RAW WATER SYSTEM IMPROVEMENTS  
CONTRACT A – PUMPING STATION  
CONTRACT B – TRANSMISSION MAINS  
CITY OF LIMA, OHIO

ARCADIS U.S., INC.  
520 SOUTH MAIN STREET, SUITE 2400  
AKRON, OHIO 44311-1010  
(330) 434-1995  
(330) 374-1095 (FAX)

ADDENDUM NO. 2  
JULY 2, 2009

ADDENDUM No. 2  
 PARTIAL PLAN VIEW  
 SHEET 8 OF 40  
 RAW WATER SYSTEM  
 IMPROVEMENTS  
 LIMA, OHIO  
 2009 ARCADIS U.S., Inc.

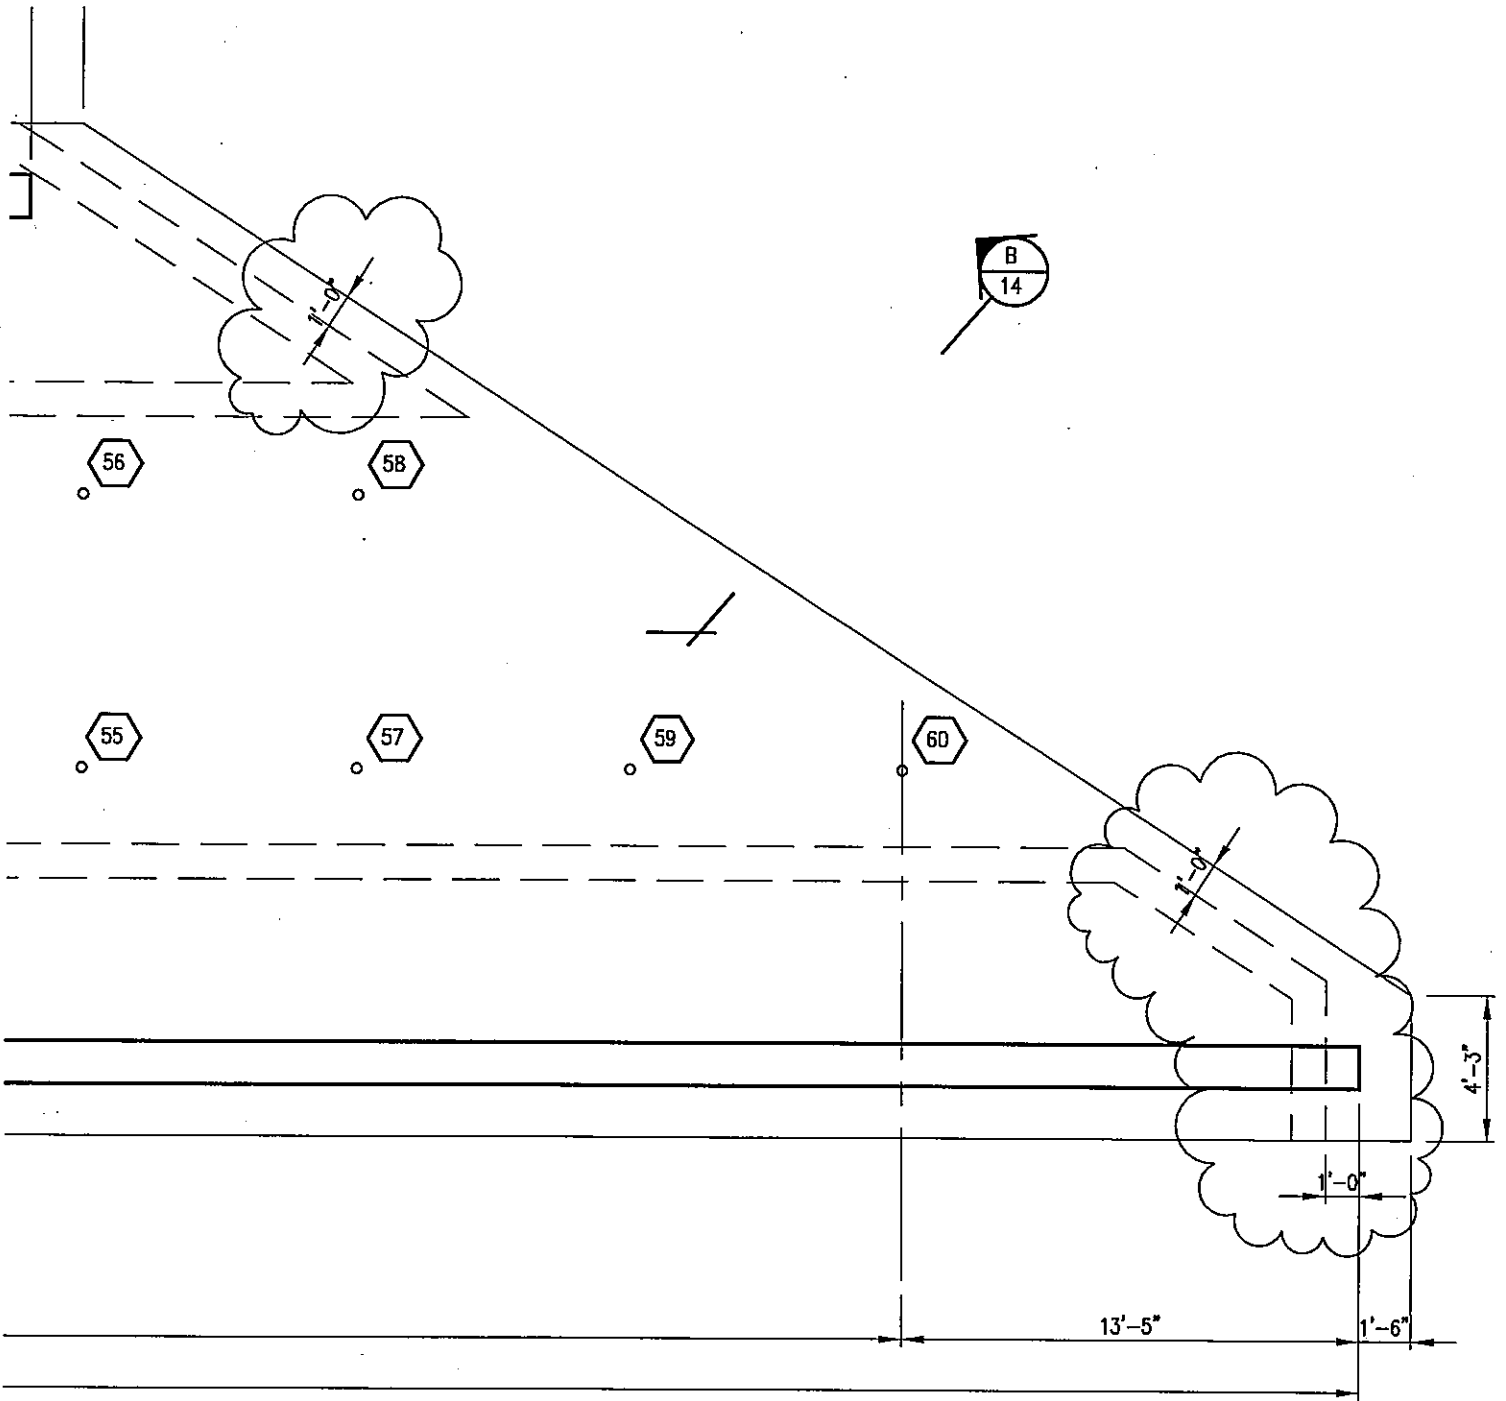
Sheet 8 of 40, Raw Water Pumping Station Floor Plan – On this sheet:

- along the right side the Plan view, near the location where the Walkway intersects with the east wall of the Intake Channel, insert a leader pointing to this location with leader note that reads "POCKET WALL 5'-0" WIDE x 1'-4" TALL x 6" DEEP FOR WALKWAY AND INTEGRAL BEAM (TYPICAL 2 PLACES)";
- insert the sheet note "NOTE: 1. COORDINATE WORK OF THIS DRAWING WITH FLOOR FRAMING PLAN ON SHT #12.";
- at the interior Stair #4 location along the building's east wall, at the leader pointing to the curb around the stair's floor opening, revise the leader note to read " 6" TALL x 10" WIDE CURB"; and
- within the Plan view, make revisions as identified on the Partial Plan View of Sheet 8 of 40 included with this addendum.

Sheet 10 of 40, Raw Water Pumping Station Sections – In the Section A view:

- make revisions as identified on the Partial Plan View of Sheet 8 of 40 included with this addendum; and
- at the dimension for the pump bowl to the wet well floor, as added by Addendum No. 1, revise the dimension text to be "0.3 to 0.5 x MANUFACTURER'S SUCTION BELL DIAMETER (MAX)".

- A6. Yes. See further clarification included in this addendum.
- Q7. On Drawing Sheet 10 of 40, Section A, right hand side, and Enlarged Detail A, please clarify how the walkway and integral beam intersect/connect to the east and west walls of the Intake Channel. Does this requires a beam pocket/key and, if so, to what dimensions?

- A7. A note has been added to Drawing Sheet 8 of 40 to clarify the pocket needed for the walkway and beam at the east and west walls of the Intake Channel exterior walls. See this addendum for revisions.

ADDENDUM No. 2  
 PARTIAL FOUNDATION  
 PLAN AND DETAIL VIEW  
 SHEET 13 OF 40  
 RAW WATER SYSTEM  
 IMPROVEMENTS  
 LIMA, OHIO  
 2009 ARCADIS U.S., Inc.

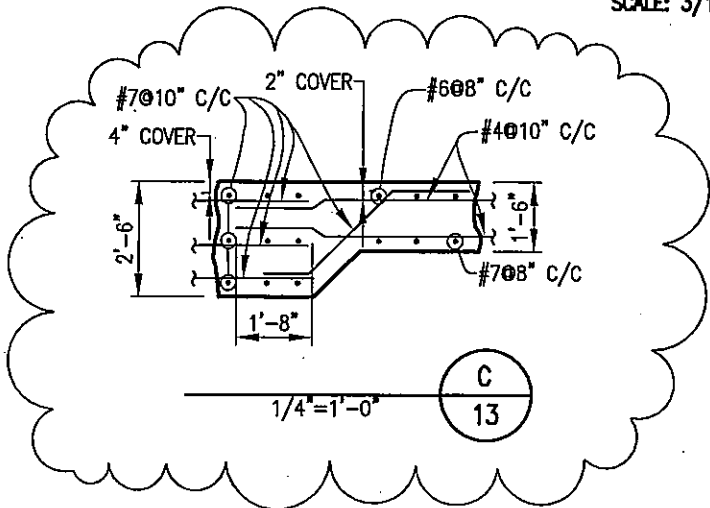
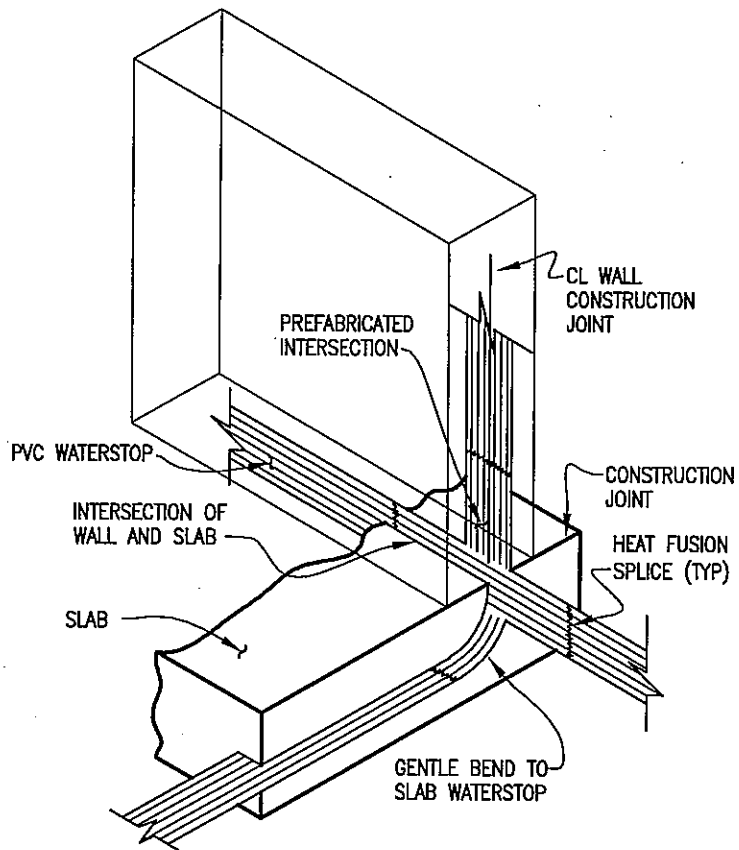
Sheet 13 of 40, Raw Water Pumping Station River Intake Channel Details – On this sheet, make revisions to the Foundation Plan view, and delete the Detail C/13 and replace with the revised Detail C/13 as shown on the Partial Foundation Plan View and Detail of Sheet 13 of 40 included with this addendum.

ADDENDUM No. 2  
MISCELLANEOUS DETAILS  
SHEET 19 OF 40  
RAW WATER SYSTEM  
IMPROVEMENTS  
LIMA, OHIO  
2009 ARCADIS U.S., Inc.

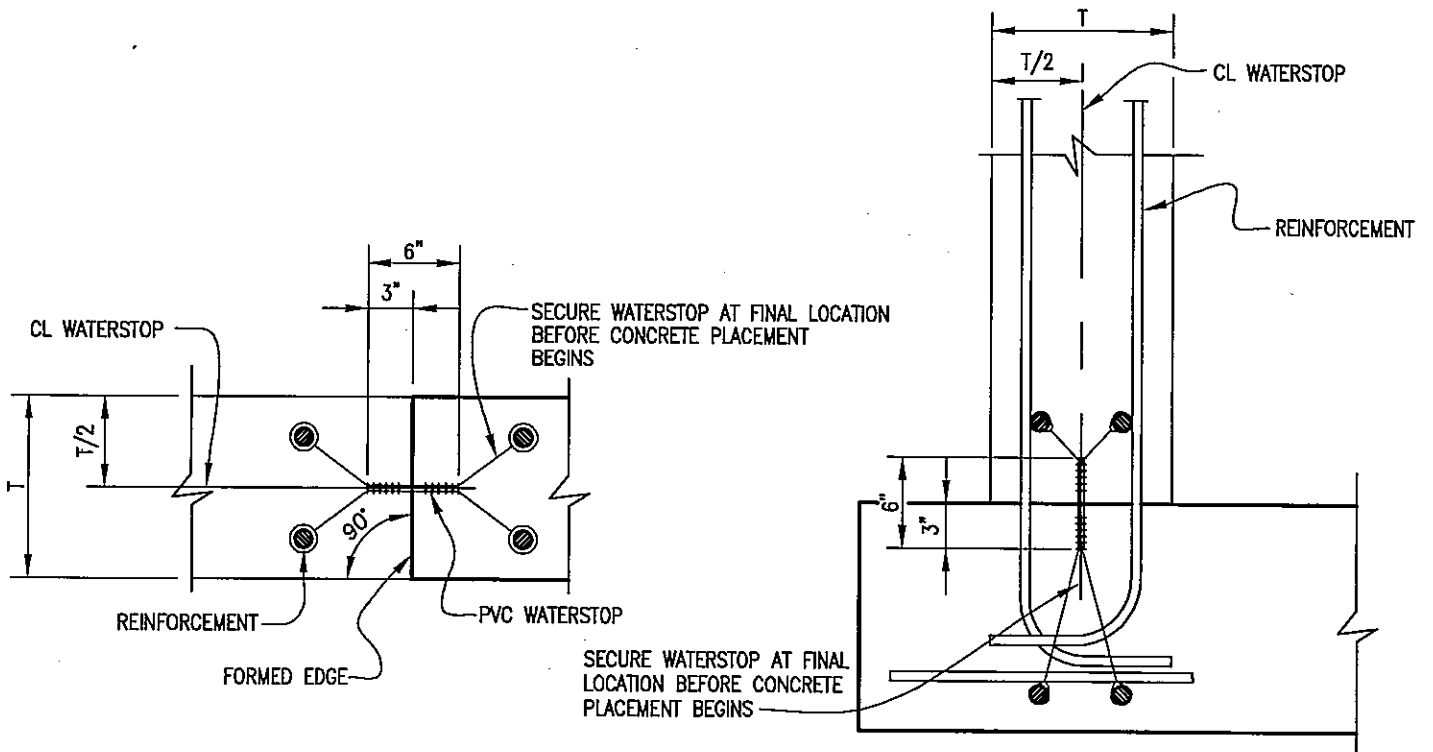
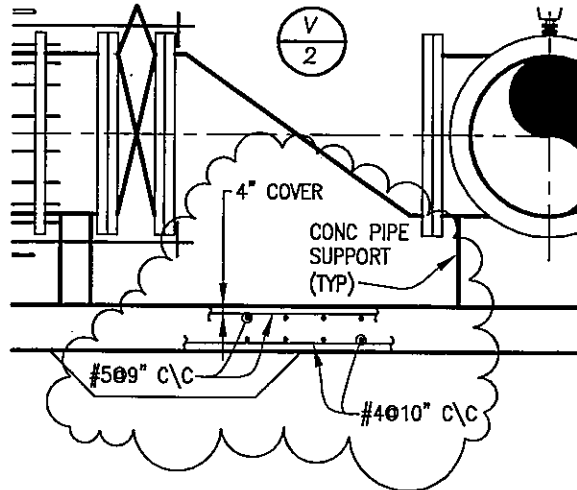
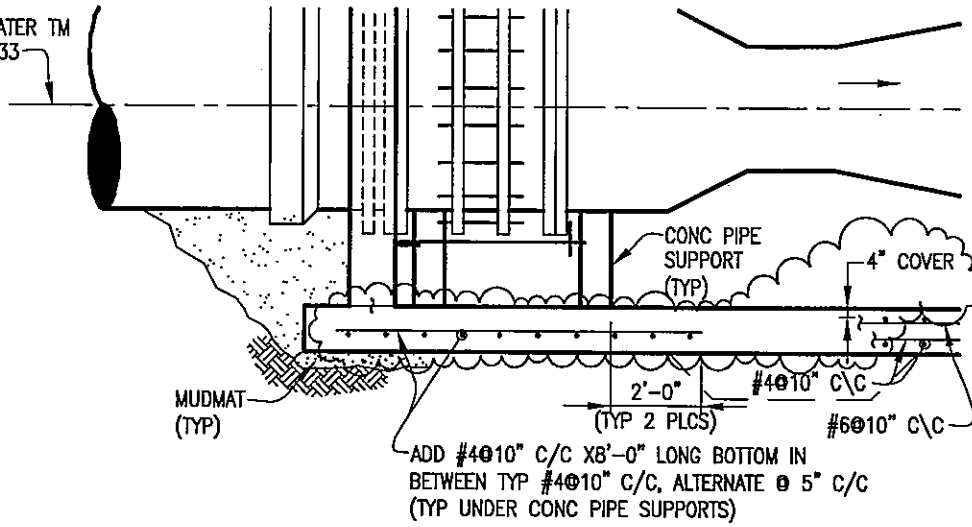
Sheet 19 of 40, Miscellaneous Details – On this sheet:

- delete the "Typical PVC Waterstop at Raised Construction Joint in Slabs and Walls" detail and replace with the revised detail "Typical PVC Waterstop at Slabs and Walls" included with this addendum;
- delete the "Typical Raised Construction Joint With PVC Waterstop, Base Slab Connection" detail and replace with the revised detail "Typical Construction Joint With PVC Waterstop, Base Slab Connection or Wall Corner Connection" included with this addendum; and
- delete the "Typical Construction Joint With PVC Waterstop, Sectional Plan or Section in Walls" detail and replace with the revised detail "Typical Construction Joint With PVC Waterstop, Sectional Plan or Section Walls and Slabs" included with this addendum.

- Q5. On Drawing Sheet 19 of 40 there is a detail titled "Base Slab Connection" " Typical Raised Construction Joint With PVC Waterstop". In reviewing the wall sections on Sheets 10, 11, 12, and 13, this detail is not indicated, nor referenced to Sheet 19. Is this detail relevant, or to be ignored?

- A5. The referenced detail is incorrect and has been revised. See this addendum for further clarification.
